**PRODUCT CAMPAIGN BULLETIN**

**APPLICABILITY:** 2019MY Ascent

**NUMBER:** WUI-94

**SUBJECT:** STOP SALE: Propeller Shaft

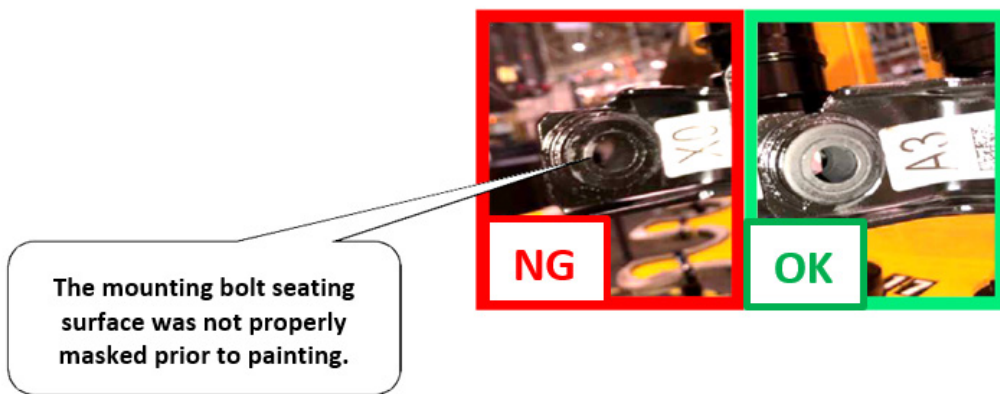
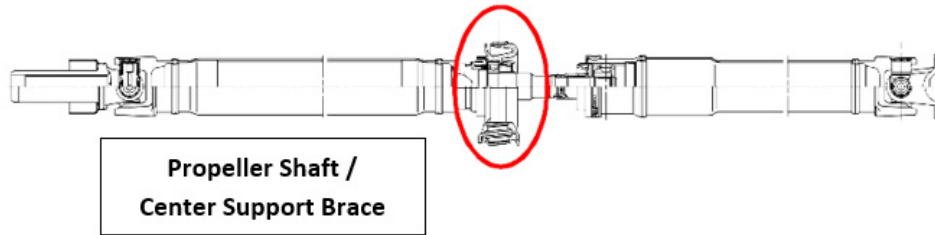
During manufacture of the propeller shaft assembly, the mounting surfaces for the two (2) center support brace bolts were inadvertently painted as shown in the **NG** example photo below. The mounting surface should be unpainted as shown in the **OK** photo. Because of this, the mounting bolt torque applied during propeller shaft installation may relax due to continued vibration. This service procedure involves replacing the propeller shaft assembly and the related hardware.

**VERY IMPORTANT:** After removing the original propeller shaft, confirm there is no residual **BLACK** paint remaining from the center support brace on both mounting surfaces of the body. The mounting surfaces **must be clean** as shown below. Use a mild solvent on a clean shop cloth to clean the area if necessary. **NEVER** use an abrasive disc or otherwise remove the tan-colored protective underbody finish coat. Doing so will expose bare metal making it susceptible to corrosion / rust.
